Subject: Cylinder Heads

Affected engine models: All engine models:

L 1700
L 2000
L 2400 EB, EE

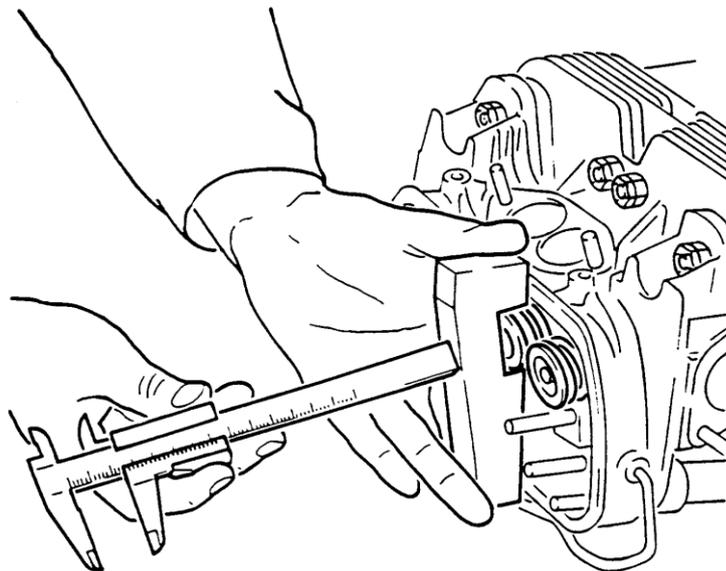
1. Remove valve cover from cylinder head on both sides.
2. Remove rocker arm shafts from both sides (4 Nuts M8).
3. Position measuring device (P/N 803.001.130.000) as pictured over each valve. Measure the distance to the end of the valve with a depth gage. The minimum allowable distance is 24.0 mm for intake and exhaust valves. Replace cylinder heads if out of limits.

Caution: If still within limits, but the distance measured already smaller than 24.5 mm, the check must be repeated every 100 hrs.
